SUBJECT: Corrected response to 841006 request for addl info re proof & review Tech Specs. Reactor protection sys rate setpoint of 11% per minute has no adverse impact on safety analysis due to rapid rate of increase of core power.

Subject: Palo Verde Nuclear Generating Station (PVNGS)  
Units 1, 2 and 3  
Docket Nos. STN-50-528/529/530  
File: 84-056-026; G.1.01.10

Reference: Letter from G. W. Knighton, NRC, dated  
October 6, 1984  
Subject: Request for Additional Information-  
PVNGS Technical Specification

TABLE 2.2-1 (Continued)

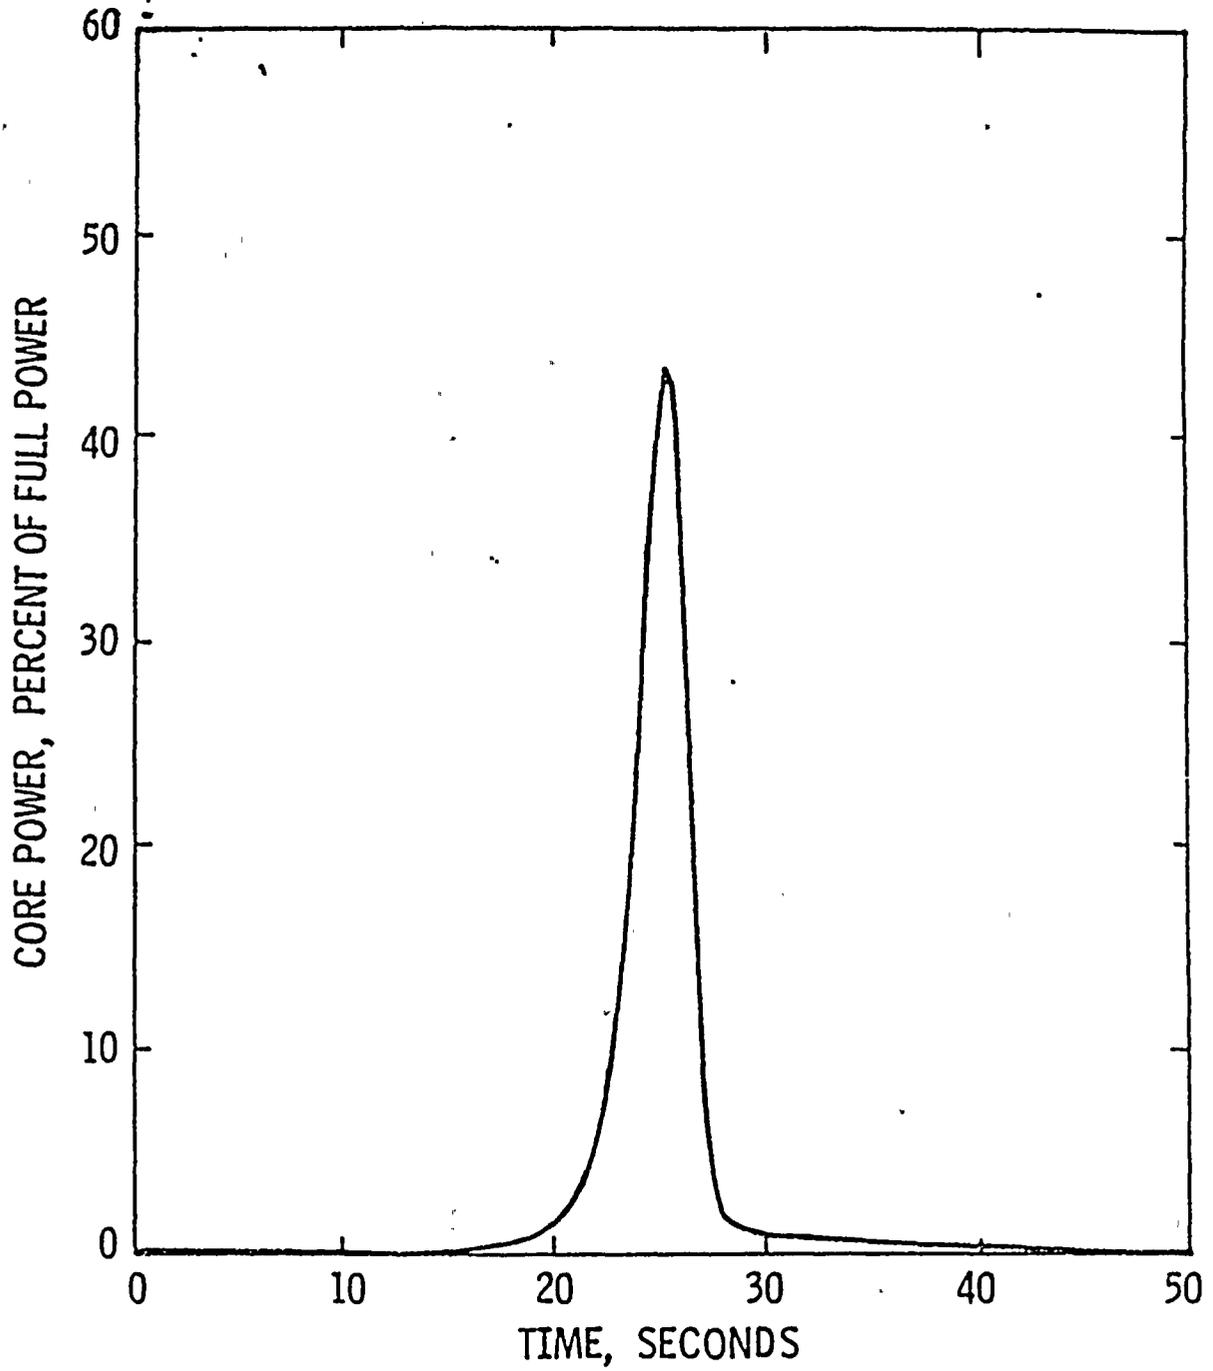
- I. Reactor Protective Instrumentation Setpoints (Table 2.2-1, Section 2.2, page 2-3 and 2-4)
  - A. Provide basis for the trip setpoint of the high pressurizer pressure on the Supplementary Protection System (SPS).
  - B. Table 15.0-4 of the FSAR indicates that the analysis setpoint of the high pressurizer pressure trip is 2450 psia. Explain how the SPS pressurizer pressure-high with an allowable value of  $\leq 2439$  psia plus instrument uncertainty could ensure the plant operation within the conditions covered by the safety analysis.
  - C. Confirm that the overpower setpoint in Table 15.0-4 of the FSAR will be modified to 11%.
  - D. Provide basis of the variable overpower allowable setpoint value of 11.0%/min in light of the safety analysis assumptions.

The SPS pressurizer pressure-high trip was referenced in the Response to NRC Question 440.5 as the second reactor trip on high pressure. Since the NRC requires that the pressurizer safety valves be sized assuming the first reactor trip during loss of load events does not function, the sizing of these valves is based on the SPS pressurizer pressure-high trip occurring at an analysis setpoint value of 2450 psia. The total instrument uncertainty for the SPS pressurizer pressure-high trip is 36 psi. Therefore, Table 2.2-1 of the Technical Specifications has been revised to indicate that the SPS pressurizer pressure-high setpoints are reduced as attached.

- C. The variable overpower ceiling setpoint in Table 15.0-1 of the PVNGS FSAR will be modified to read 117% for all transients except for steam and feedwater line breaks inside containment for which it will remain at 116%.
